REPORT TO THE JOINT REGIONAL PLANNING PANEL (SYDNEY WEST)

JRPP Reference number:	2013SYW024
Development Application:	DA/62/2013
Address:	143 and 169 Macquarie Street, Parramatta
Property description:	Lot 100 DP 609944 and Lot 1 DP 701300
Proposal:	15 storey retail/commercial building over basement parking
Estimated value:	\$118,967,030
Date lodged:	7 February, 2013. Additional information received 8 August, 2013 and 20 August, 2013
Owner and applicant:	Parramatta City Council
Council Planner:	Anthony Newland
Report Author:	Brad Roeleven - City Plan Strategy and Development

Figure 5: Drawing by Architectus showing breach of sun access plane

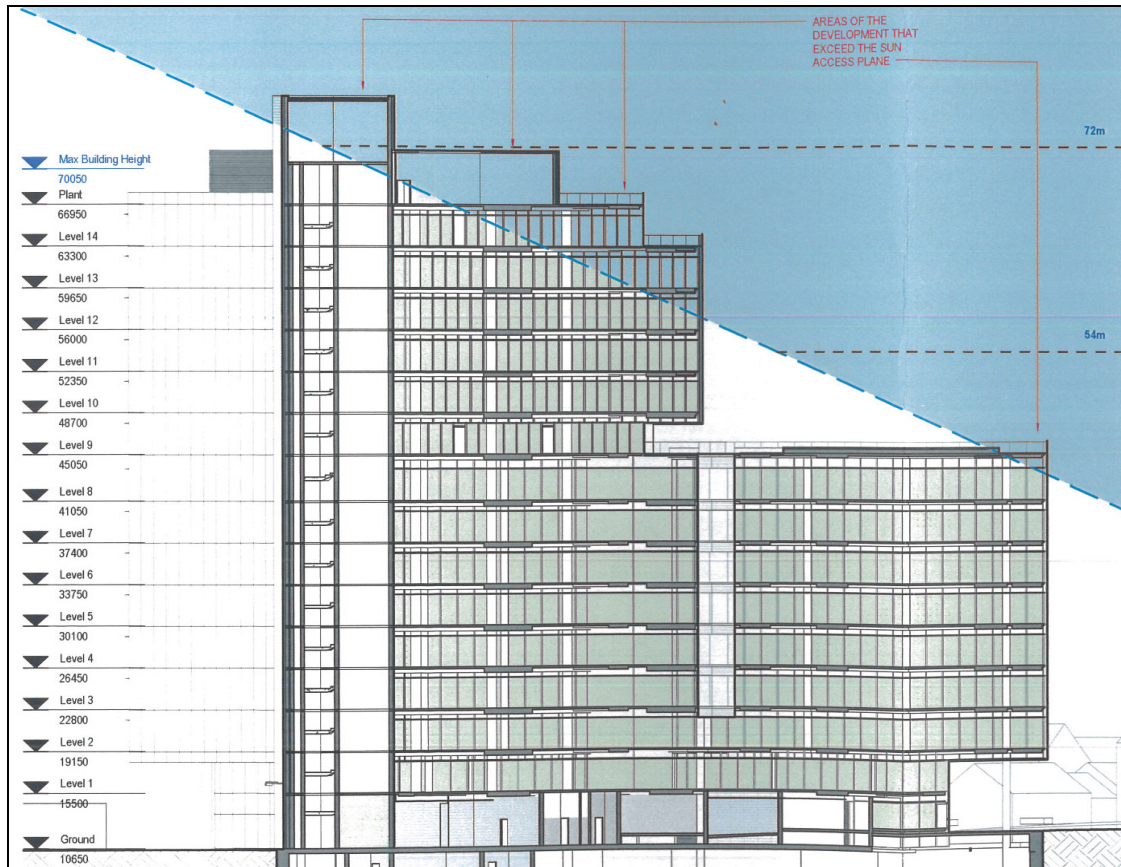
The proposed building does extend outside that sun access plane, and therefore the terms of clause 29E of the LEP are relevant. It is noted that clause 29E is worded to read as a prohibition, yet section 2.9 of the DCP provides some flexibility regards strict compliance. Council therefore obtained independent legal advice as to the interpretation of clause 29E. That advice concluded the clause is not a prohibition, but a development standard, which is able to be varied (if appropriate) by means of the mechanism in clause 24 of the LEP.

The extent to which the building extends outside the sun access plane is quantified below:

In evaluating this matter it is concluded:

- It is agreed the extent of the impact is limited, in both extent and duration;
- The DCP does contemplate variations to sun access plane controls, with concessions relative

to impacts on the Lancer Barracks from additional shadow cast by new buildings. The structure of those provisions however is considered to relate to a separate sun access plane for Civic Place, and not Lancer Barracks site. Nevertheless, those same provisions provide a basis upon which to evaluate the impacts on the Barracks resulting from breaches of its sun access plane control, and in this regard the extent of the impacts is consistent with the DCP concessions;

Figure 6: Drawing by Architectus showing alternate setout lines

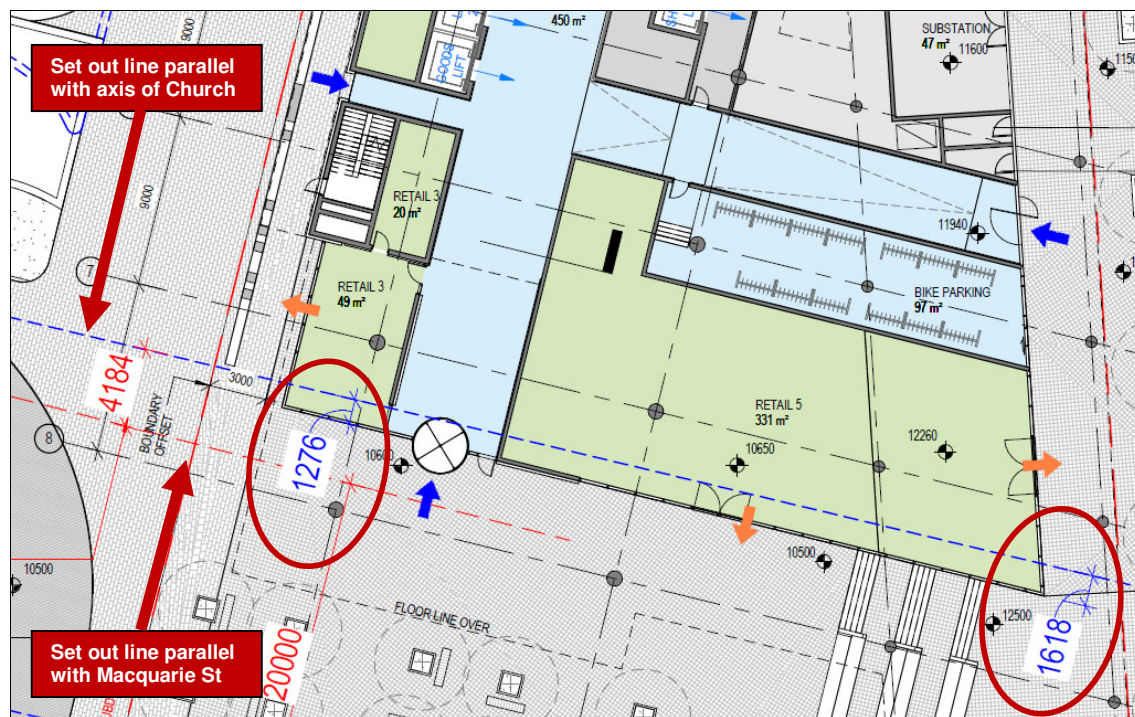
The DCP controls for Parramatta Square provide for a 40m central open space corridor through the precinct to support a series of public spaces. The western end of this corridor is to be terminated by St John's Church, which sits on the western side of Church Street Mall. The DCP provides that the width of the corridor is to be measured as 20m either side of the centre of the Church, and that the alignment of the corridor is to be set parallel to the axis of the Church.

Council's Urban Design Team has identified that the building has instead been determined by aligning the northern edge of the open space corridor to be parallel with Macquarie Street, creating a circumstance where the building encroaches into the open space corridor by between 1.5m -1.8m. It is the Urban Design Team's preference for the building to align with the axis established by the alignment with the Church, as intended by the DCP.

Provided below is an extract from a drawing prepared by the applicant that illustrates the variance between the two approaches to the set out line, and the degree to which the ground floor of the building encroaches past the DCP setout line, being between 1.2m - 1.6m:

Figure 7: Alternate locations for basement driveway ramp

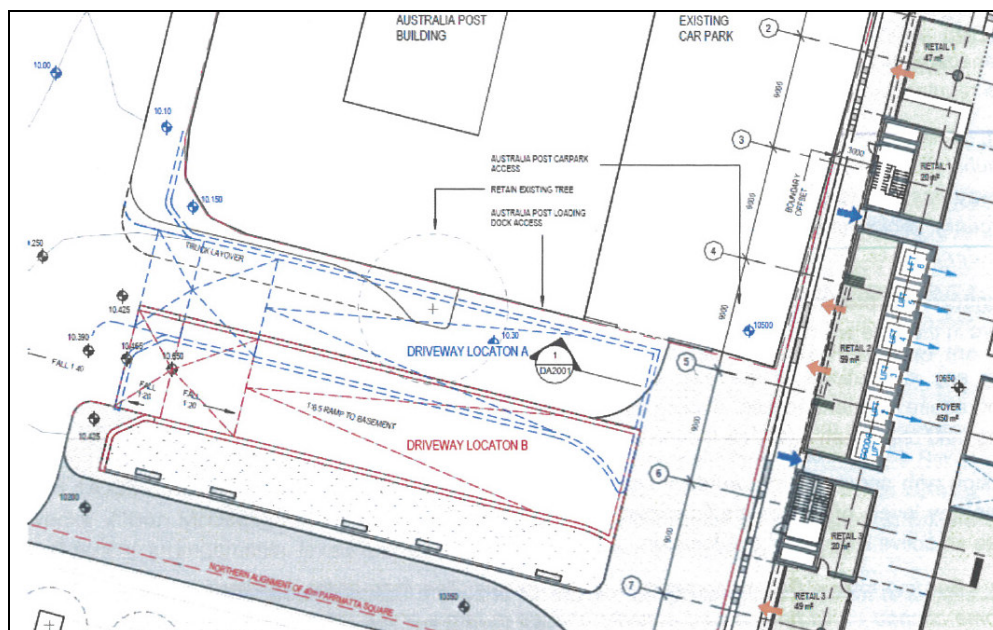
However given the short term operating requirements associated with the continued operations of Australia Post, this application is seeking consent for two separate locations for the driveway access ramp, as shown on Figure 6 below, and as follows:

- Option A is the preferred position, predicated on the success and favourable timing of the development application for No. 153 Macquarie Street;
- Option B is intended only as a 'temporary' arrangement, to be constructed if it is not possible to secure Option A. It is acknowledged however that Option B potentially could be a permanent solution if the project for No. 153 Macquarie Street fails to proceed, and must therefore be satisfactory in its own right, both from an urban design and functional perspective.

Council's Urban Design Team has noted the two ramp locations, and has not objected to either provided interface issues with the public domain are properly managed. This primarily relates to the space available to the south of the driveway to ensure that a future building can 'sleeve' the ramp from the public domain, without encroaching into the main public plaza. The preferred dimensions for that building 'sleeve' noted by the Urban Design Team are able to be generally achieved, notwithstanding the discrepancies in the 'set out' the Square, previously discussed.

- (a) *Any private vehicular dive structure is to be constructed in Position 'A' as shown on drawing (number, name, date), but only if the owner of Lot 1, DP 863571 gives written permission to the location of the vehicular dive structure in Position 'A', and/or if a development consent for the redevelopment of Lot 1, DP 863571 and Part Lot 1, DP 791300 is issued showing any private vehicular dive structure in Position 'A'.*
- (b) *If (a) above cannot be met by December 31, 2014 any private vehicular dive structure must be constructed in the location of Position B, as shown on drawing (number, name, date).*
